Product / Process Change Notification (PCN)

PCN #: PCN_IndPD_20200410
Affected Series: WE-PD 1280; 744770xxx,

PCN Date: January 10, 2020
Effective Date: April 10, 2020

Label example for pad printing
(13th digit marked in red)

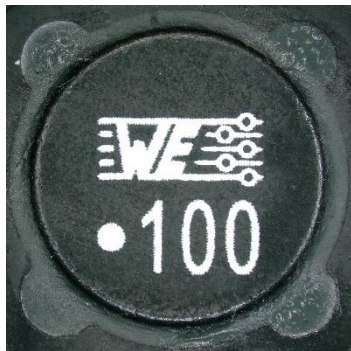
- 1.) All electrical and mechanical properties of the parts will remain the same.
- 2.) Pad- and Laser-Printing will be used from now on.
- 3.) Printing method can be identified on the label by the 13th digit in the lot number.

Lot.-No. for Pad-Printing: xxxxxxxxxxx0xx

Lot.-No. for Laser-Printing: xxxxxxxxxxx6xx
